# Performance Bulletin

## Improved Plastic Bypass

Improvements have been made to the 60049 plastic bypass valve, and will be integrated as a running change beginning June of 2005.

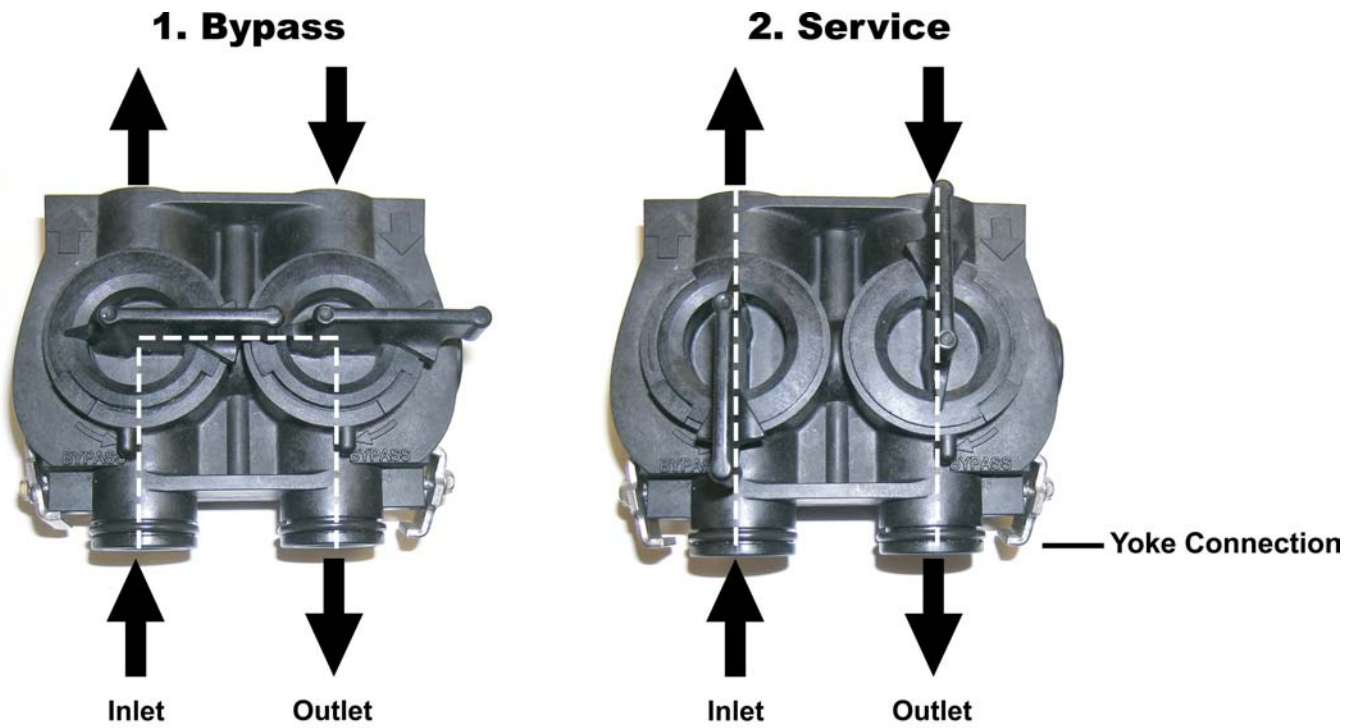
- **Handle Improvement:**
  - Arrows (designed on handles) indicate water flow in service
  - Accommodates a drain line straight out the back when in service or stand-by
  - Easier to operate when o-rings have become seated over time
  - Improved aesthetic design
- Accommodates the drain port on the 5600 Valves (1/2" straight hose barb (part number 13308) and 90 degree elbow (part number 12338))
